Camden Cycling Campaign

7th March 2024

Clerkenwell Road Safe and Healthy Streets Consultation

The section of Clerkenwell Road between Grays Inn Road and Rosebery Avenue

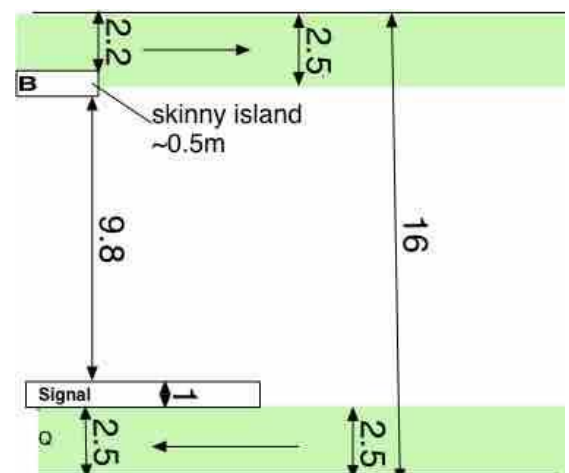
This section is crucial: the eastbound cycle lane (proposed width 2.1m) needs to have sufficient capacity for queueing at Rosebery Avenue and the westbound cycle lane (proposed width 2.05m) for queueing at Gray's Inn Road. The road width here is ~16m (Appendix C2). The three motor traffic lanes require 9.75m which leaves 6.25m for the cycle infrastructure.

We suggest that 2.5m stepped cycle lanes should be used through this section, these lanes being protected by:

- 1m wide x 8m long signal islands on the approaches to the two junctions.
- And skinny bollard islands on exit from the junctions

The sketch on the right shows how the approach to Gray's Inn Road might work.

In a similar way, the approach to Rosebery Avenue would have the signal island on the eastbound lane and the skinny bollard island on the westbound lane.

Clerkenwell Road to the east of the junction with Rosebery Avenue

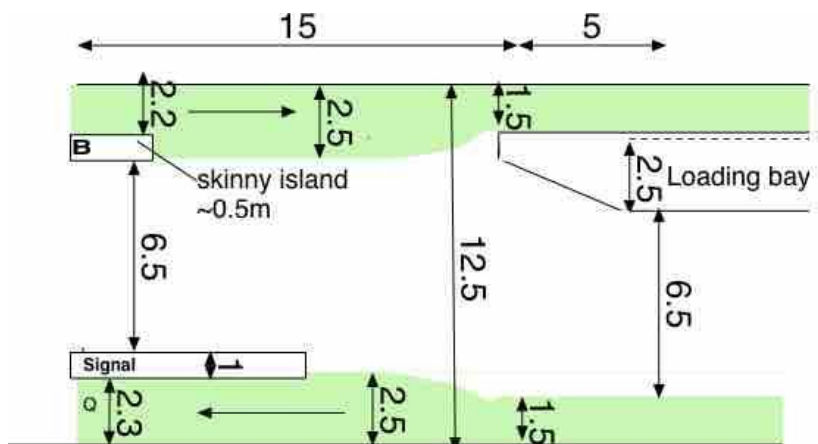
The proposed cycle lane widths are 1.5m on entry to the junction and 1.65m on exit, both of which are severely inadequate.

Appendix C3 suggests that the lead up to the loading bay is about 15m long and the width of the road about 12.5m.

We suggest that the loading bay island should not start until 15m east of the junction so as to allow for about 15m of wider cycle lanes close to the junction. To allow for the gradual narrowing of the road and the cycle lanes at the loading bay we suggest that the bay area is shifted to the east by about 5m (Sheet 4 of the consultation drawing appears to leave some space between the loading bay and the parallel crossing).

The sketch suggests how our proposed layout might work.

Sadly we can see no alternative to reducing the cycle lane widths to 1.5 m as they pass the loading bay.

Appendix C

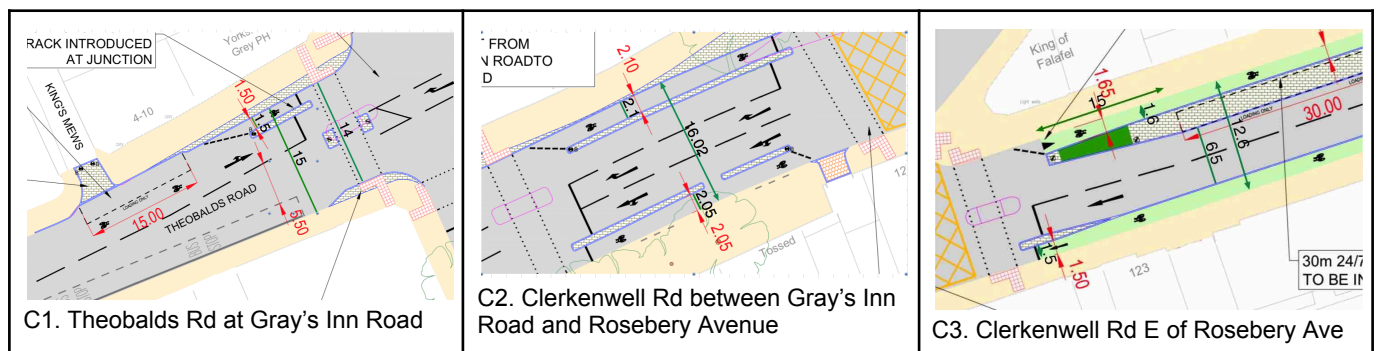
The approach lane width of 1.5m is unacceptable: to allow for queueing the width should be 2.5m. The current road width here is ~15m which should be more than enough for 2x 2.5m cycle lanes, 2x 3.25m motor lanes and the 1m signal island. See Appendix C1. In the short term if it is unfeasible to move the bus stop on the south side of Theobalds Road, we suggest that the footway widening should be postponed in order to widen the cycle lane on the approach to the junction.

The map clips below are taken from Sheets 2 and 3 of the consultation drawing. We have added green lines to obtain further approximate measurements.

C1 suggests that Theobalds Road on the approach to Gray's Inn Road is about 15m wide

C2 suggests that the road width here is about 16m.

C3 suggests that the road width here is about 12.6m, while the lead up to the loading bay is about 14m long.
